COUNTY OF ULSTER

Track and Corridor Inspection

November 10, 2015

The intent of the inspection was to examine corridor conditions for a review of Catskill Mountain Railroad's (CMRR) proposed rail with trail alignment. This joint-use rail with trail concept was strategic as submitted in the CMRR business plan, and the first half-mile above Hurley Mt. Road is already back in service as part of the Polar Express program. Our task as we saw it was to also perform field measurements of cuts and fills for potential evaluation of excavation issues, rather than vertical placement, of a parallel trail. No previous measurements of lineal distances had been done between Hurley Mt. Road and Basin Road to provide evaluation data.

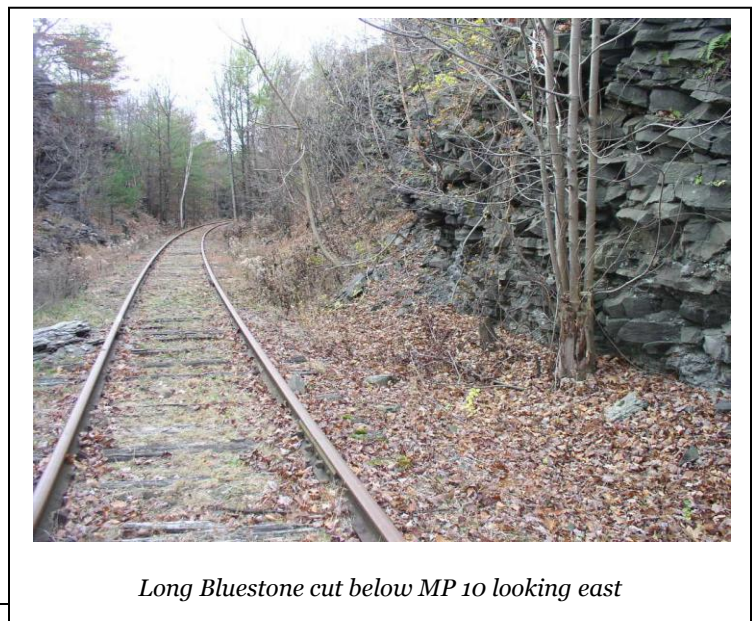
MP 10 – immediately below Basin Road – the track enters into a long curve within a deep Bluestone cut. This cut is opened wide to 33-35 feet, and appears to verify some historic information that cut areas were deliberately widened in order to provide more fill material in other adjacent areas. This is a very wide cut profile and the rock faces appear very stable. Rock faces are steep, and were likely blasted.

Rail in this area on the curve was 105# Dudley, comped down to 90#AS (33-foot sections) rolled in 1913, verifying the original reconstruction. Lackawanna 1912 90# rail was also identified.

This cut area was very long - with depths of 25 feet over the majority from west to east, and slowly dropping down to ground level further east. Cut distance was 3300 feet verified with counted rail lengths and essentially verified with valuation maps. Additional excavation in this hard Bluestone would require blasting, but the remarkably wide cut width would allow re-alignment of the track to one side to allow for recreational trail clearance. Blasting of this area is likely not feasible, as it passes directly behind several commercial concerns. Track relocation is the most feasible approach in this zone due to well-excavated distances and existing poor tie conditions with few if any non-defective ties. Tree growth within the cut zone in this area is also heavy and would require grubbing; this is one of the zones far more practical to deal with as a 'railroad' than a vacated corridor for those issues.

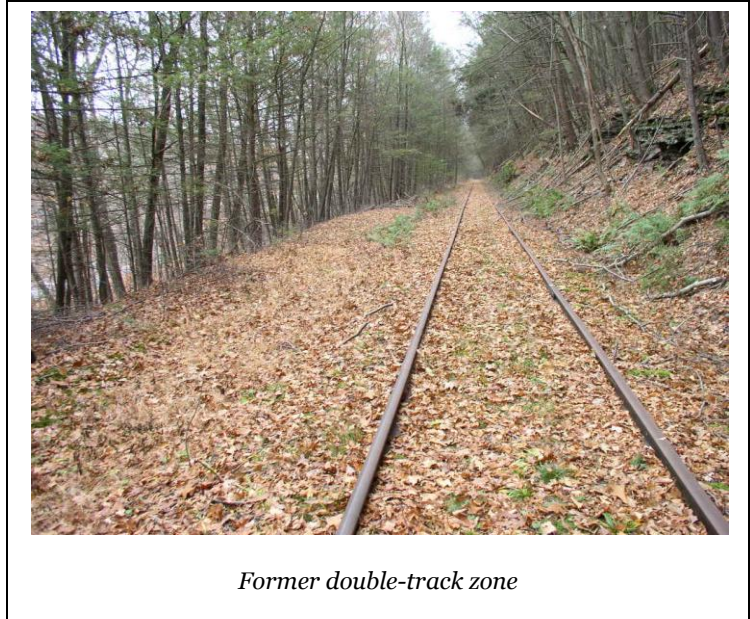
The ‘very best’ rail with trail location on the entire railroad begins approximately at MP 7.28 and continues south to MP 6.74; this was an excavated and widened passing siding area with the second track placed to the north side and then removed. CMRR plan shows the trail to this north side; this assumed continuation of this alignment north of this point on retaining wall. At this point there could either be a crossover of the trail to the north side of the ROW, or any heavy track rebuilding could relocate the track

over to the north side to allow easy location of the trail continued on the south side without a crossover. This is one location on the entire alignment that allows relatively easy, full-width trail profile with little excavation or filling necessary. For comparison, this amounts to half a mile of relatively easy parallel (and full-12’ width) construction that at minimum extends any work to 6.74 to easily be continued to 7.28. For any ‘rail with trail’ alternative, this should be emphasized as it allows the railroad the track/time distance to MP 7.28 with any further issues only from 6.74 to MP 6 – ¾ of a mile of more difficult co-location issues with a ‘free’ half-mile at the end with minimal conflict. As in other locations, when the track needs a virtual rebuild from scratch due to tie conditions, relocating the track is a viable alternative to reducing crossovers or gaining additional clearance.
